# SERVICE BULLETIN

from: TRIO-KENWOOD COMMUNICATIONS, INC.

TS-930 & other models

SUBJECT	TS-930S SSB TX Tone Quality	DATE	3.29.83
---------	-----------------------------	------	---------

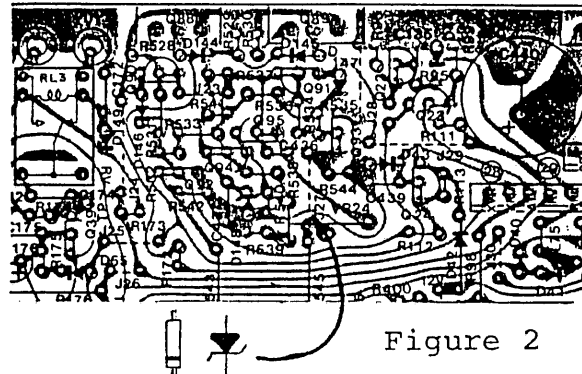
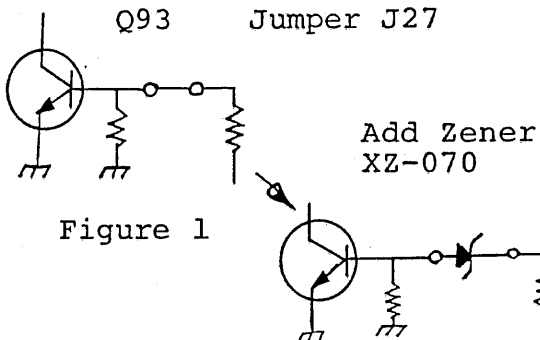
A loss of receiver sensitivity (6-30db) may be caused by shorted switching diodes in the Signal Unit (X57-1000-XX). The following procedure will increase the capability of the unit to withstand high RF voltage levels.

2. Change diodes D15 through D33 from BA282's to 1s2588's. Change only the defective diodes when making the repair.
3. Figure 3 shows a circuit that is capable of withstanding antenna input levels of up to 50 Watts. Use this on units that may be subject to high levels of RF. (This is an optional change that may not be done in warranty.)

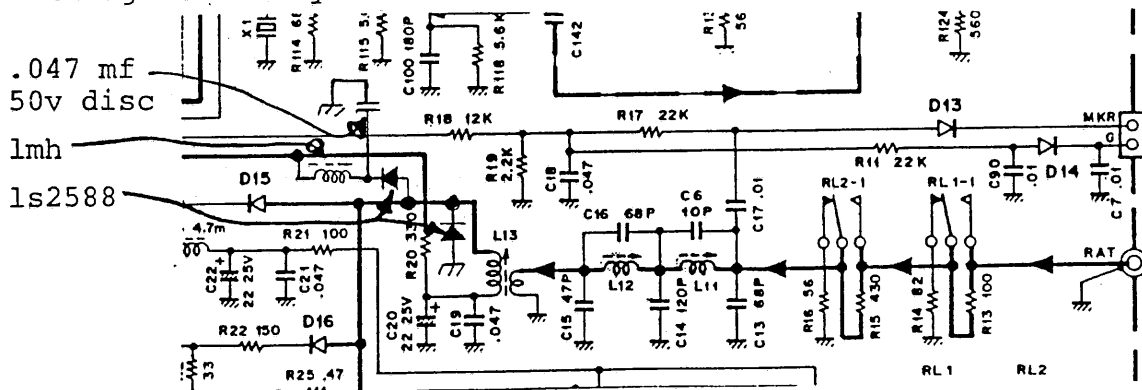
1. Replace Signal unit jumper J27 with an XZ-070 zener diode. (PCB coordinate C-1, see figure 2.)

Component side view

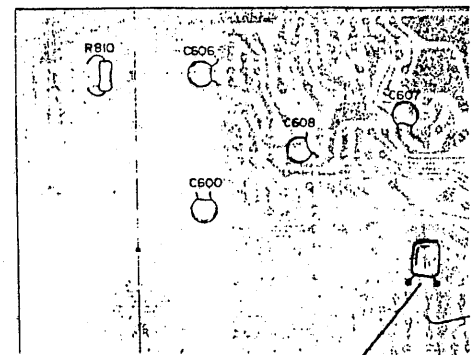
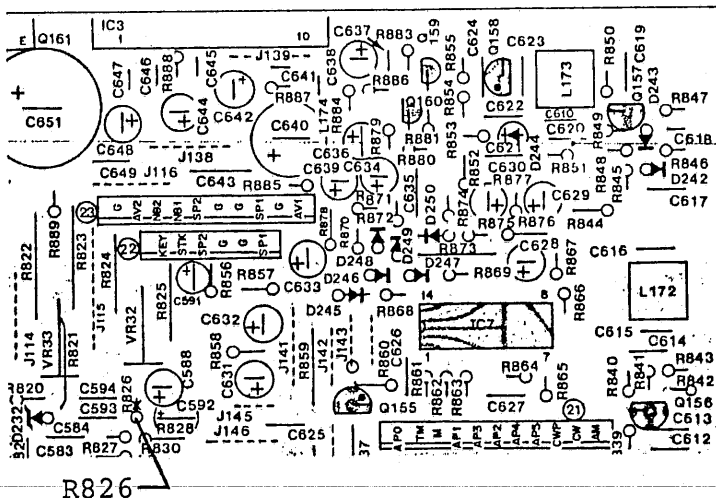
On the Signal Unit (X57-1000-XX) change R826 from a 1K ohm to a 10K ohm, part no. RD14CB2E103J and remove C601, a .022 $\mu$ F capacitor from the foil side of the circuit board.

Remove C601

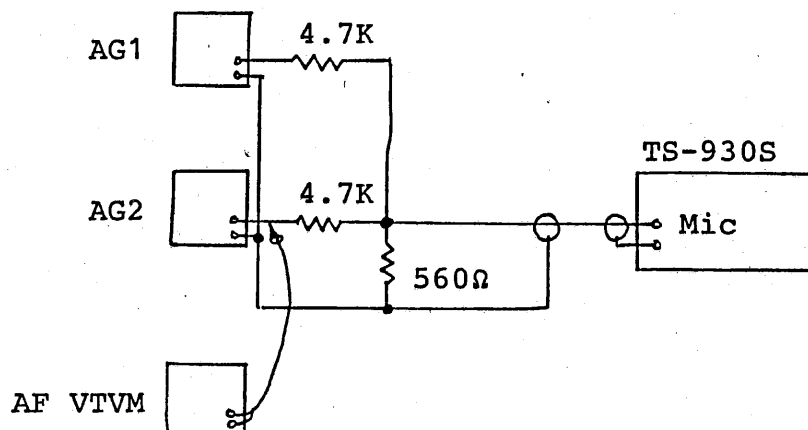
1. Preset the TS-930S controls as follows:
  - 1) MODE: .....LSB
  - 2) Disconnect the DRV connector from the Signal Unit.
  - 3) Confirm that CAR2 frequency is the same when switched from transmit to receive. If it does not stay constant adjust VR23.
2. Connect the oscilloscope probe to R176 in the Signal Unit.
3. Connect the two Audio Generators as shown in the figure below. Set AG1 to 300 Hz and AG2 to 2.9 KHz.

Figure 2

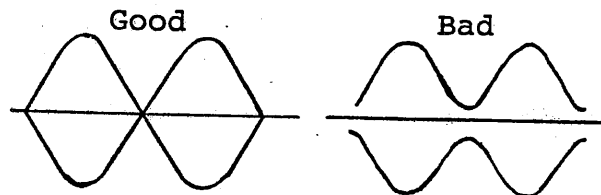
4. Ensure that the output level of AG1 and AG2 are equal by using the AF VTVM.
5. Connect the cathode of D133 to that of D132 in the Signal Unit using a 0.01μF capacitor.
6. Clip the lead of D124 and place the STBY switch to SEND.
7. Adjust TC4 (CAR1 8.8315 MHz for USB) so that a complete tone waveform is observed, as shown in figure 2. Return to REC, and resolder D124.

8. Remove the  $0.01\mu\text{F}$  capacitor installed in step 5.
9. Set STBY to SEND and adjust TC3 (CAR2 8.375MHz ) so that a complete two tone signal is displayed, as in Fig. 2.
10. Return to REC, and reconnect the DRV connector. This completes the simplified alignment procedure.

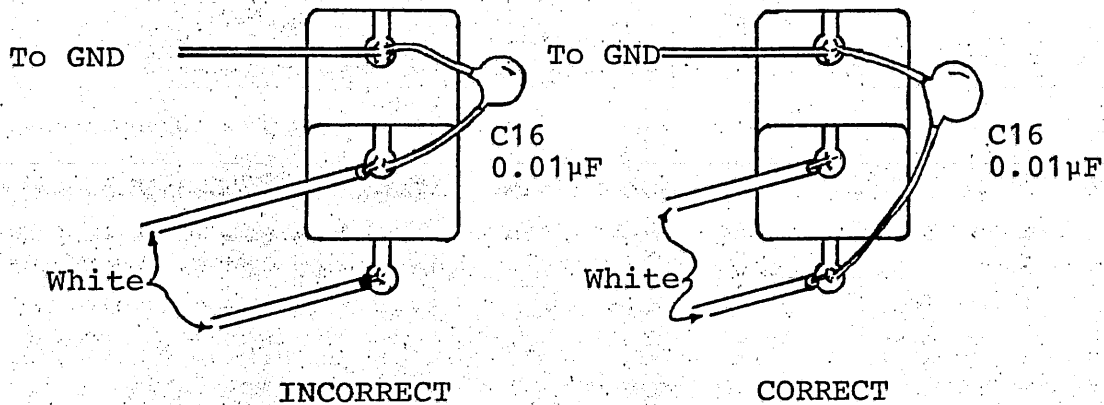
For reports of RF Feedback from the external speaker, especially when using a vertical antenna, or a linear amplifier, check for correct installation of capacitor C16 on the EXT. SPKR jack.

Schematic

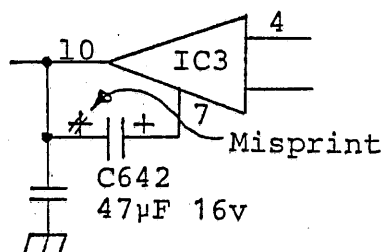
The cause may be that Signal Unit (X57-1000-XX) capacitor C642 is installed backwards. See figures below. Please change your service manual schematic to reflect the correct positioning when you check the board.

Foil side view

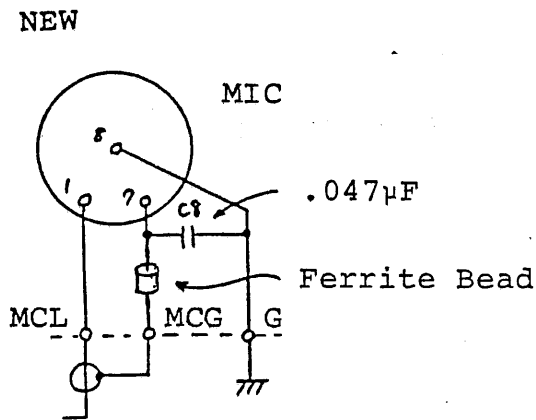
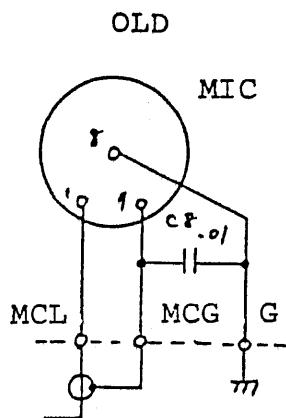
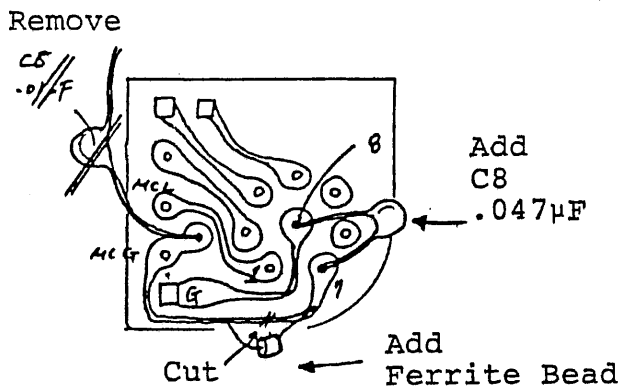
Some users may report RF feedback to the MIC at low frequencies, for example: 3.5 Mhz.

Make the following changes to SW unit (J) (X41-1410-00):

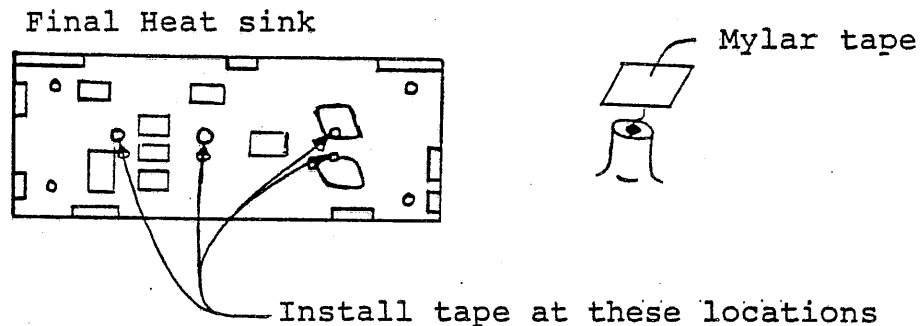
Some users have reported that the ALC meter indication occasionally jumps during long key down periods on the 28 Mhz portion of the bands. The symptom may be caused by the ground foil of the Final Unit (X56-1430-00) coming in contact with one or more of the projections on the final heat sink, due to expansion when the temperature rises.

Apply mylar insulating tape to the projections on the heat sink, to prevent reoccurrence of this symptom. See figures below.

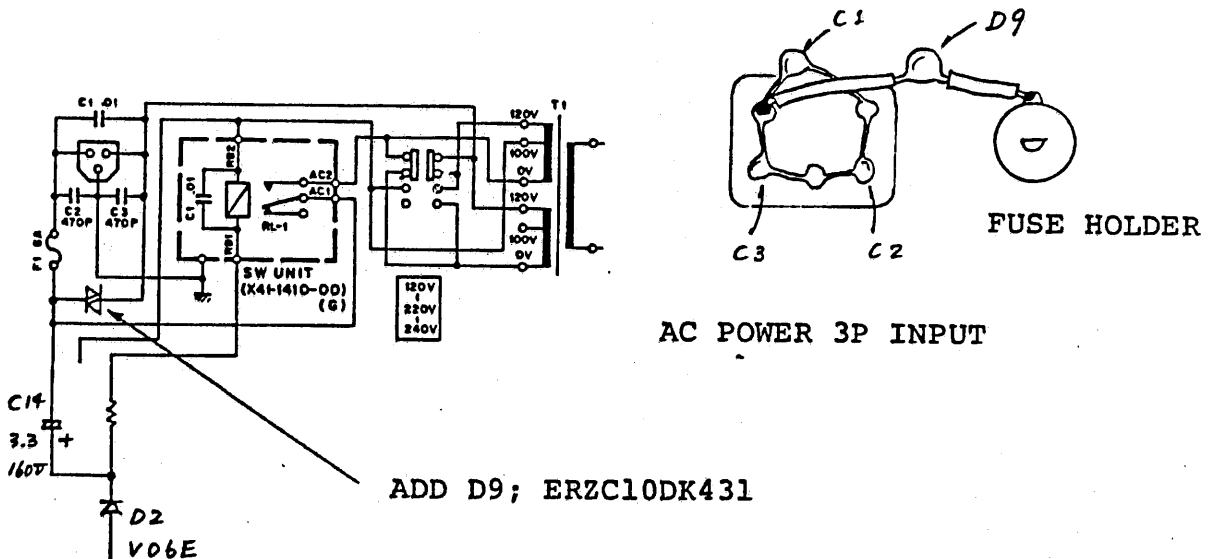
A line surge (exceeding approximately 4.5KV) due to static electricity or nearby lightning discharge may short power relay diode, D2 (V06E), and cause electrolytic capacitor C14 (3.3 uf) to break down. This results in relay chatter and the relay contacts may finally weld.

Addition of the surge absorber to the primary power supply input circuit, as shown below, should help avoid this type of failure.

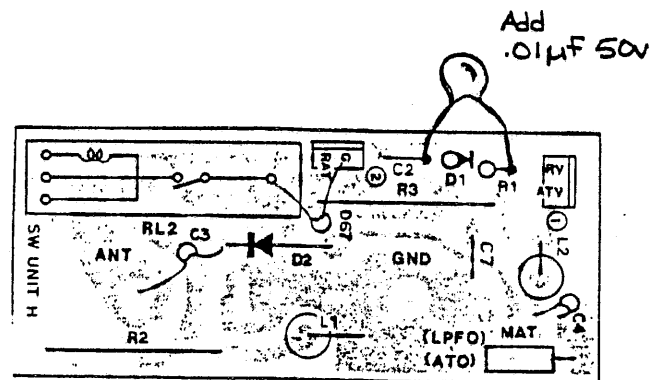
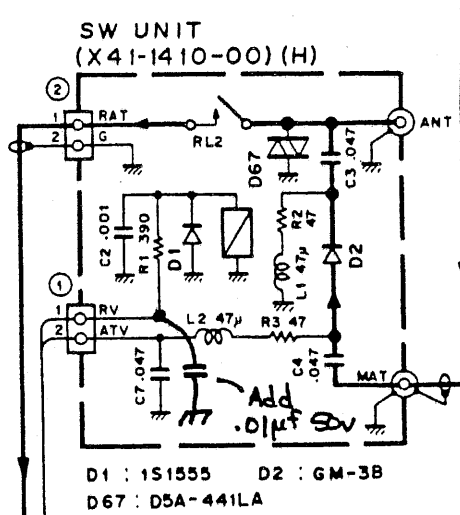
Some users have reported an internal beat tone that appears every 10 KHz, when operating in the range of 20-21.5 Mhz. Apparently the RV terminal of Switch Unit H is being affected by the 1st loop of the PLL unit. The cure is relatively simple. Add a .01 uf 50v disc ceramic capacitor on the RV line of Switch Unit H as shown below.

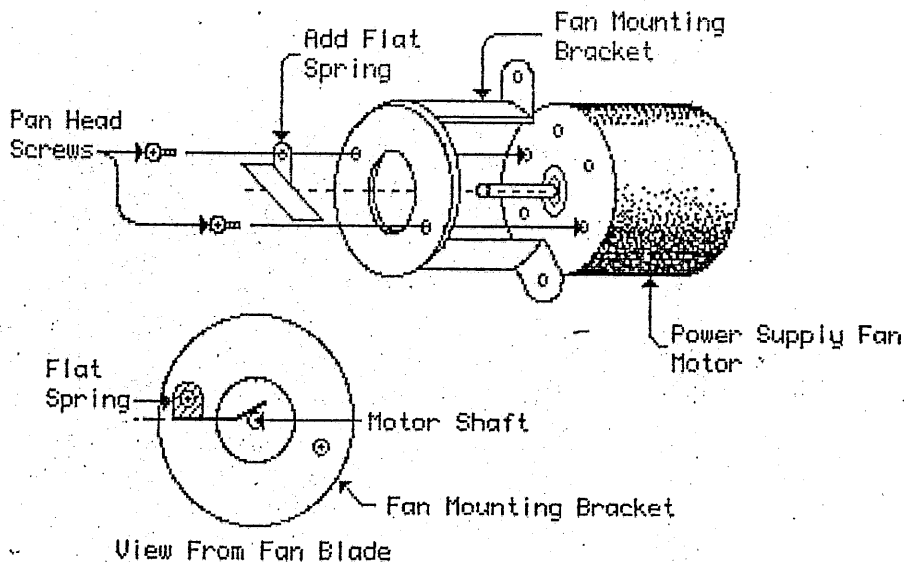
Some users of the TS-930S have reported that the Power Supply Fan motor makes excessive noise. This fan motor was originally designed to drive a pulley system. By adding a small amount of lateral tension to the motor shaft this noise is reduced or eliminated. The procedure listed below should correct any tendency of this motor to make noise.

Add the Flat Spring as shown in the figures below.
